ADDENDUM NO. 1

Date: July 7, 2017

Project: DSA Required ADA Improvements at Leonardo da Vinci

JOB NUMBER: _____ SHEET NUMBER:
 DATE: _____ DRAWN BY: _____
**ADD-1
 CCD-2
 GS101.1**

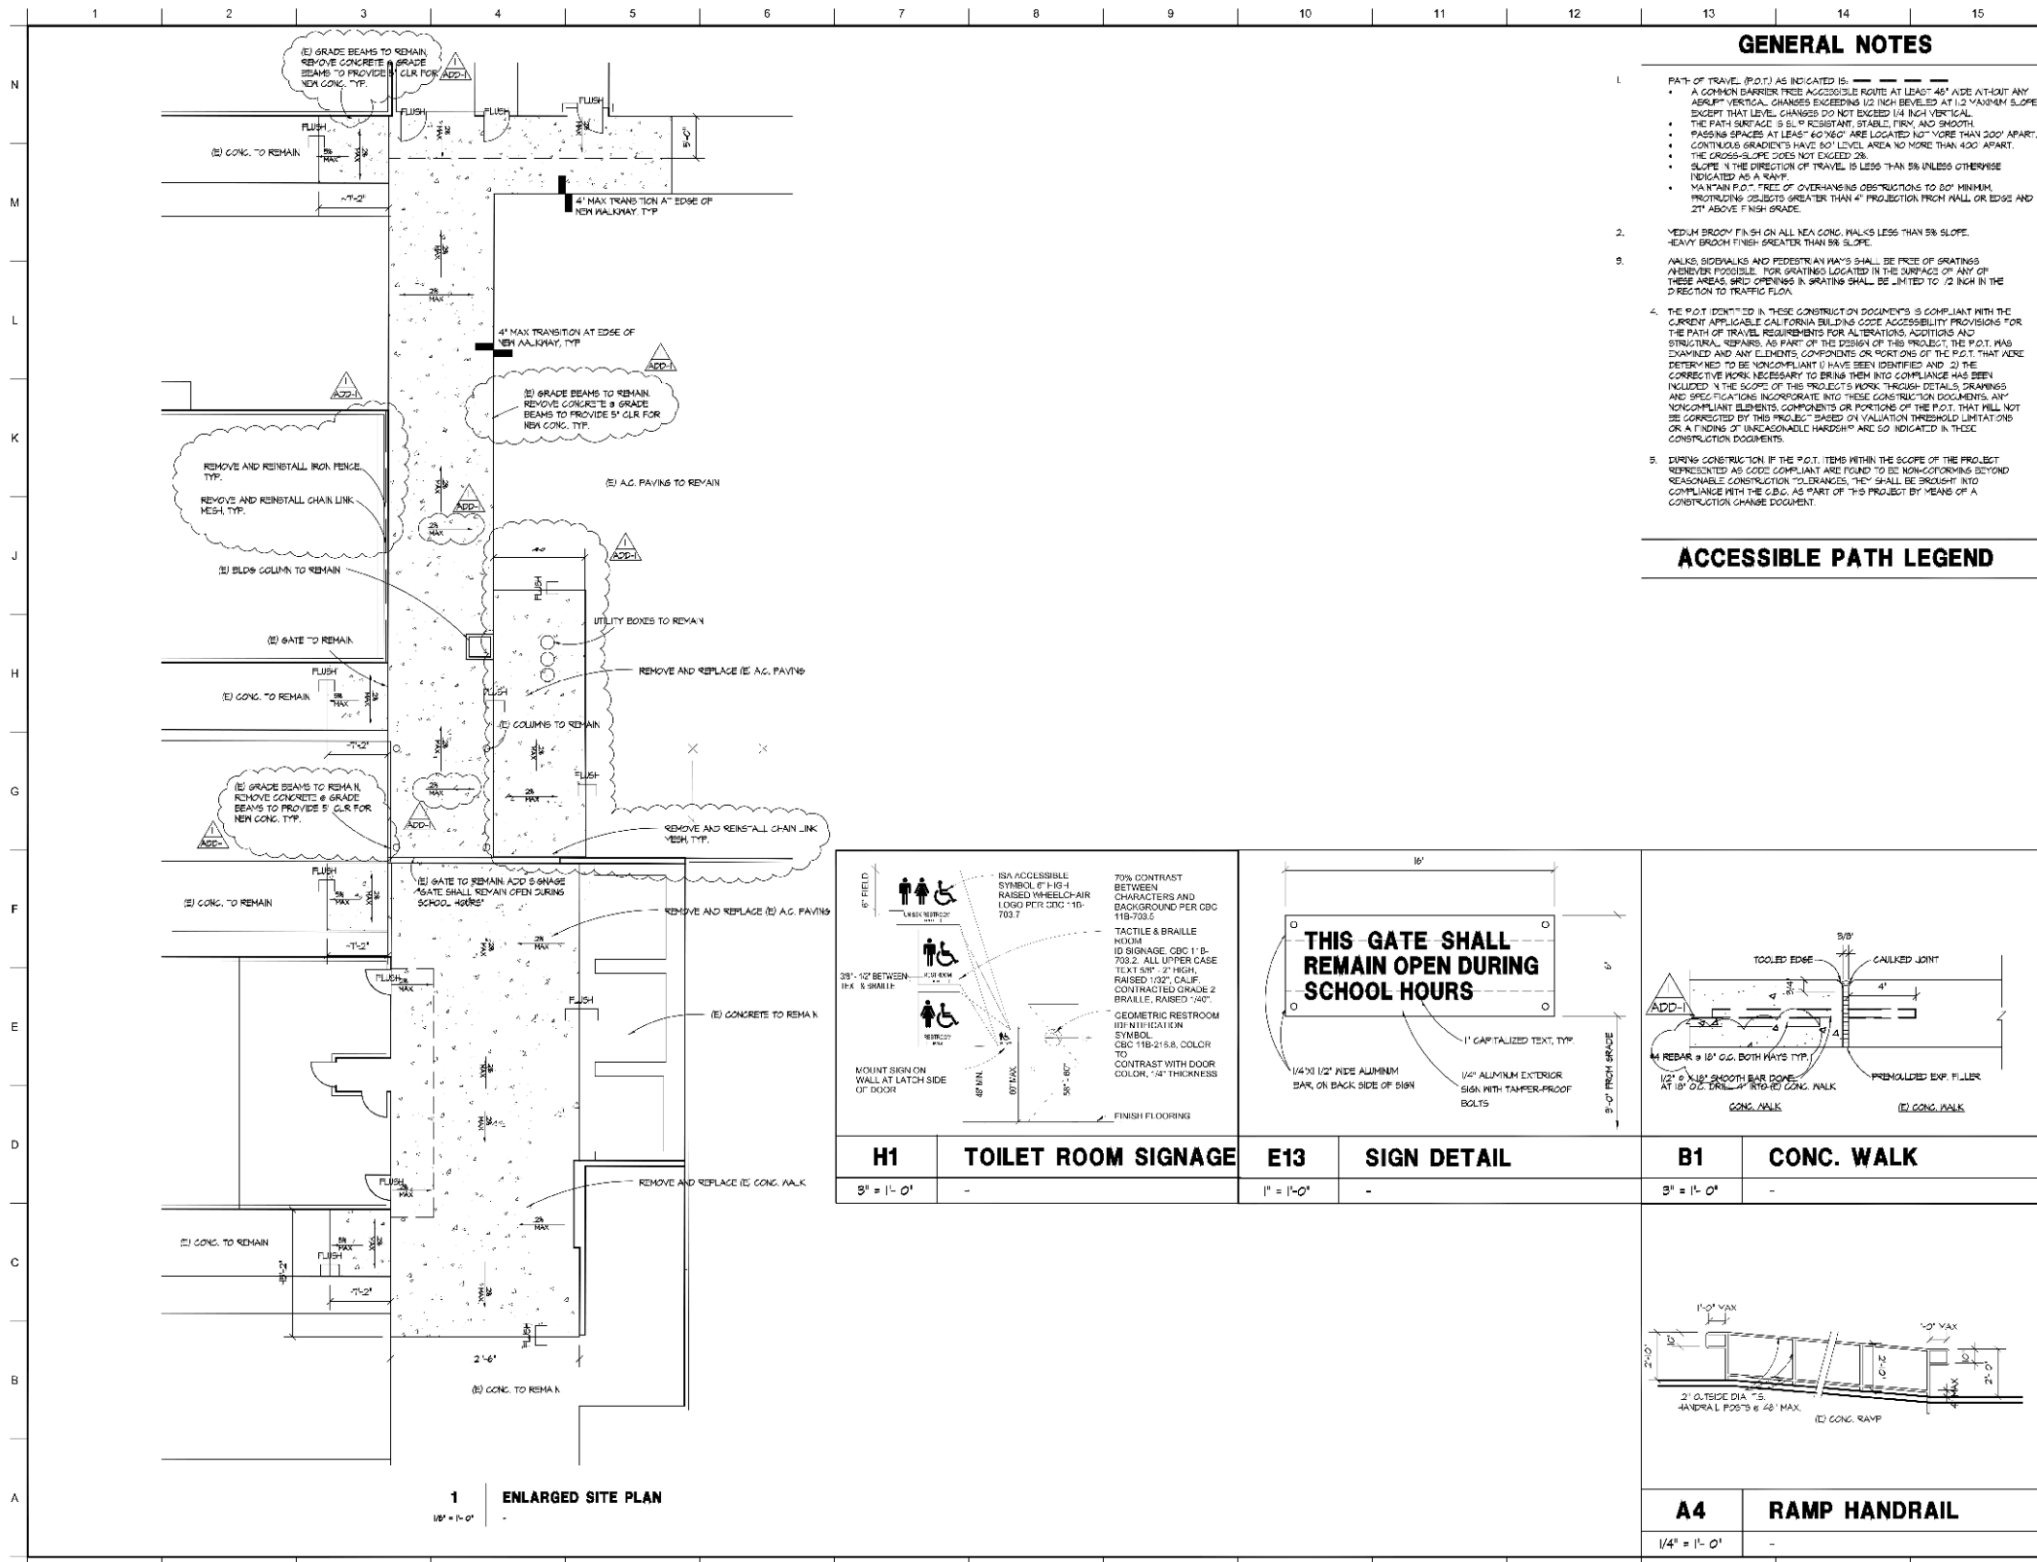
1. **ITEM # 1.3** Sheet CCD-2 GS101.1 – Accessible Path Site Plan: Replace this sheet in its entirety with the attached Sheet **ADD-1 CCD-2 GS101.1**. All changes have been clouded and marked with a delta.
2. **ITEM # 1.4** Sheet CCD-2 GS101.2 – Accessible Path Site Plan: Replace this sheet in its entirety with the attached Sheet **ADD-1 CCD-2 GS101.2**. All changes have been clouded and marked with a delta.
